Vaporizer Part Number Consolidation

Vaporizer P/N 11A17 is no longer available and is now replaced by P/N 11A17-001. These two parts are similar, the only difference being the location of the fuel outlet plugs.

Top view of the 11A17-001 showing the inlet at the 3 o'clock position and three outlets at the 6, 9 and 12 o'clock positions.

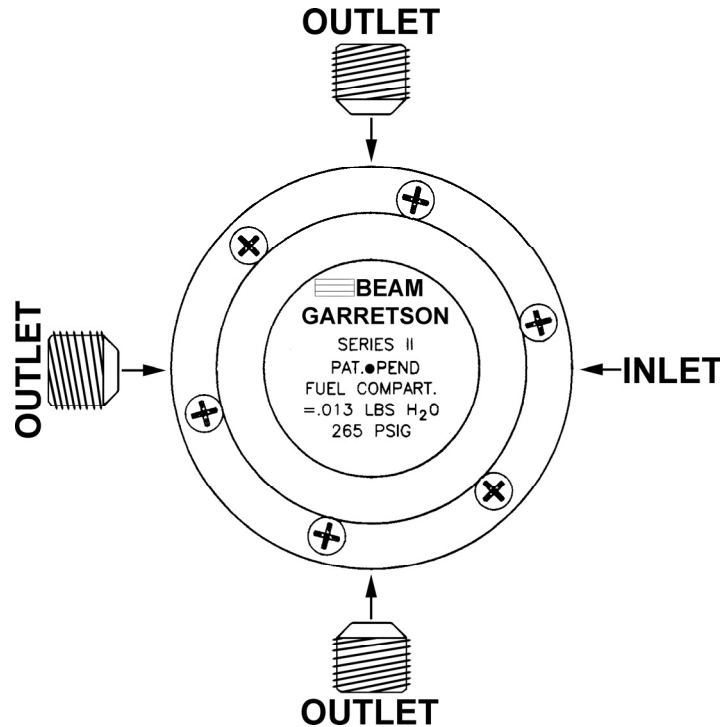
The Vaporizer will come with plugs in two of its three fuel outlets. If it is necessary to relocate the fuel outlet connection, the plugs can be removed and relocated to fit the existing application. When installing the plugs, use Loctite 567 on the threads and torque to 100 in/lbs. (11.3 Nm).

If it was necessary to relocate one of the fuel outlet plugs, pressurize the regulator fuel inlet with 100 psi of air pressure and check the plugs for leakage with a commercial leak detector before placing the regulator in service.
